File Number	PLSUP-2511-0065		Contact	Jason Mozol, jmozol@duluthmn.gov	
Type	Special Use Permit for Major Utility Facility		Planning Commission Date		December 9, 2025
Deadline for Action	Application Date		November 13, 2025	60 Days	January 12, 2026
	Date Extension Letter Mailed		November 26, 2025	120 Days	March 13, 2026
Location of Subject		Corner of E Palm St and Blackman Ave			
Applicant	City of Duluth, Engineering		Contact	Nathan Bruno and Ryan Granlund	
Agent	LHB		Contact	Heidi Bringman	
Legal Description		010-2710-05980, 010-0360-00571, 010-2710-06001			
Site Visit Date		June 16, 2025	Sign Notice Date		November 25, 2025
Neighbor Letter Date		November 13, 2025	Number of Letters Sent		29

Variance to Shoreland Setbacks
Special Use Permit
Palm Street Pond

PALM STREET PERMANENT STORMWATER MANAGEMENT SYSTEM IMPROVEMENTS

LANDSCAPE PLANS
SHEET NO. LA02 OF 3 SHEETS

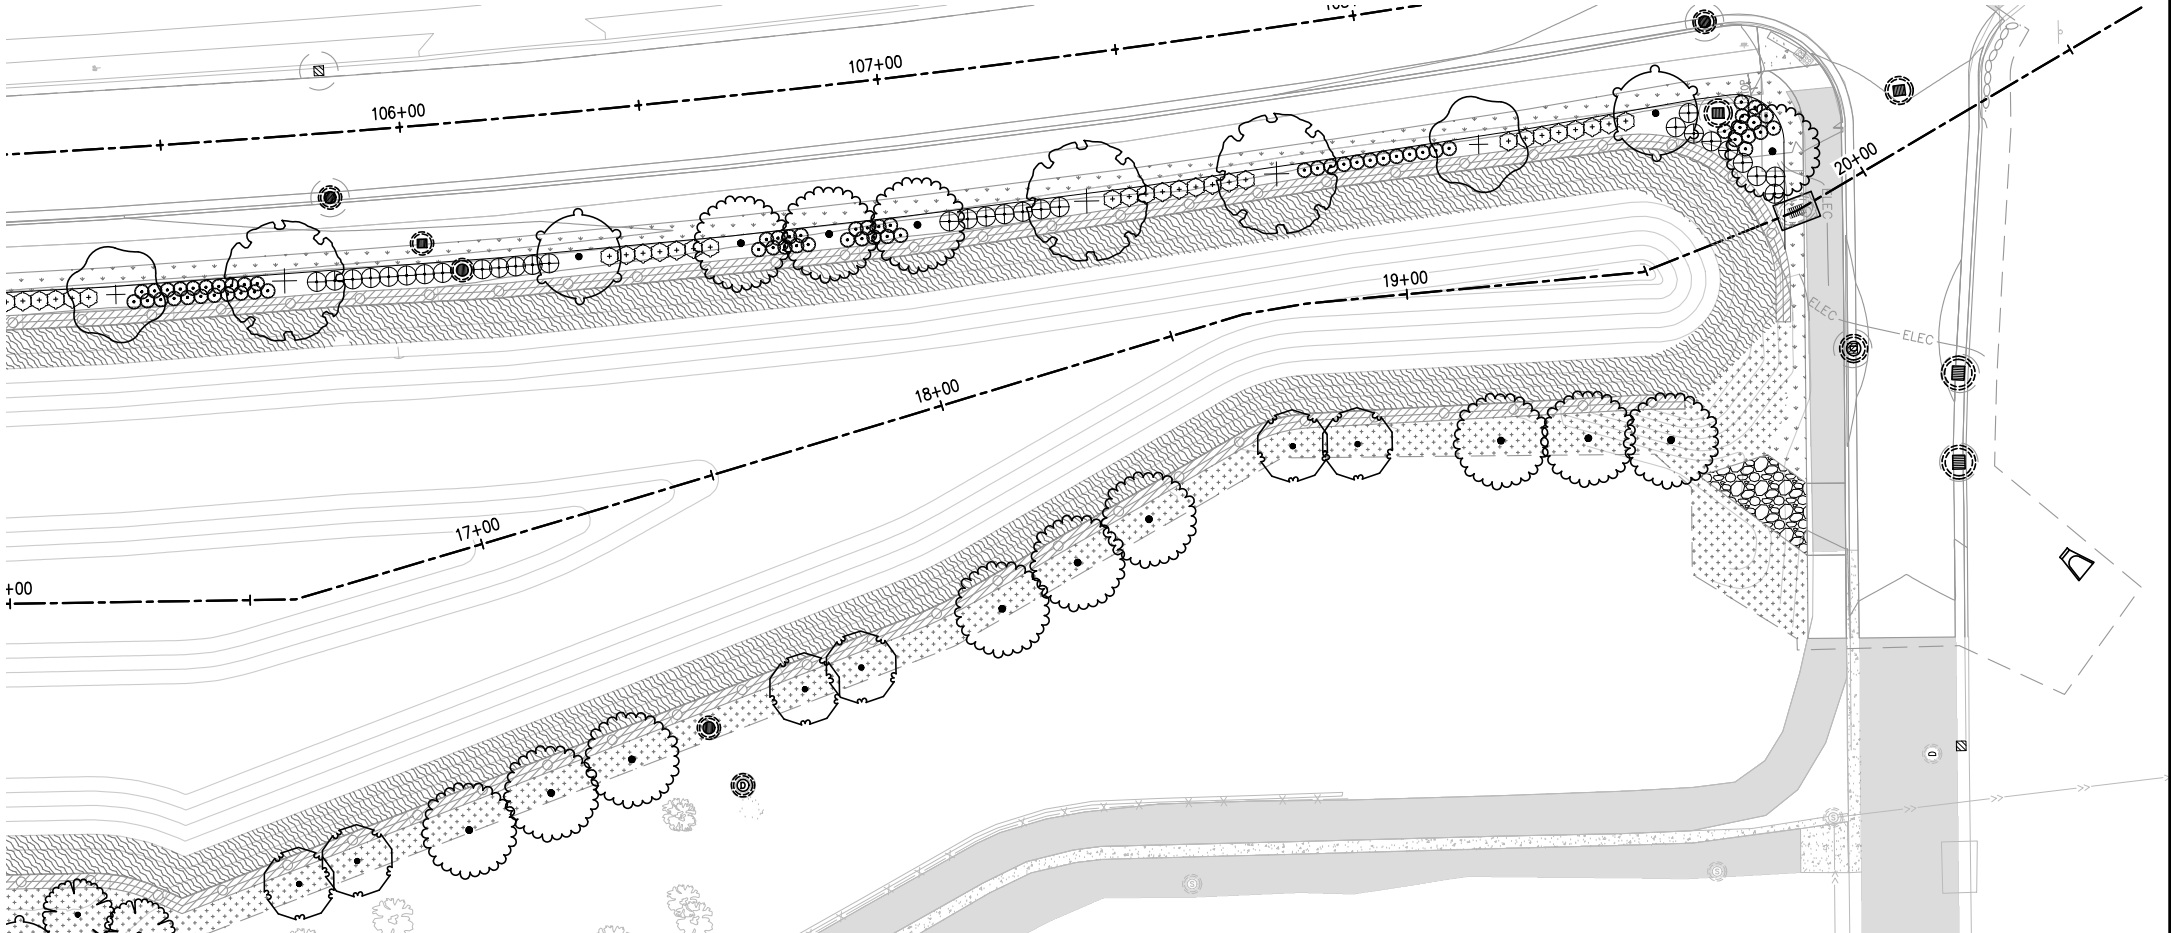
- *Street frontage landscaping (Sec 50-25.3)-* 28 trees and 37 large shrubs must be provided along Palm St and Blackman Ave. The applicant is proposing 28 trees and 143 shrubs.

- *Buffer for industrial uses abutting residential uses (Sec 50-25.5.C)-* A vegetated buffer with trees is proposed along the southern edge of the site. The buffer is not the full 15' required width on the western end and does not have the minimum trees or shrubs required. To offset these shortfalls, the applicant is proposing to exceed the minimum required shrubs along the street frontages. This project does not produce any noise or light impacts often associated with industrial uses. Given these facts, the land use supervisor has approved this alternative landscaping plan as satisfactory with the flexibility allowed in Sec 50-25.8.

- *Tree preservation (Sec 50-25.9)*- 24 trees are proposed to be removed. To mitigate these impacts, 72.4 caliper inches of replacement trees must be planted. The applicant proposes to plant 127.5 caliper inches of new trees.
- *Screening, Walls, and Fences (Sec 50-26)*- A fence permit must be applied for and issued prior to installation of the perimeter fence.

- 1) The project must be constructed and limited to the plans submitted with the application.
- 2) Permitting for wetlands must be completed prior to any soil disturbing activity.
- 3) A fence permit must be applied for and issued prior to installation of the perimeter fence.
- 4) Any alterations to the approved plans that do not alter major elements of the plan may be approved by the Land Use Supervisor without further Planning Commission review; however, no such administration approval shall constitute a variance from the provisions of Chapter 50.
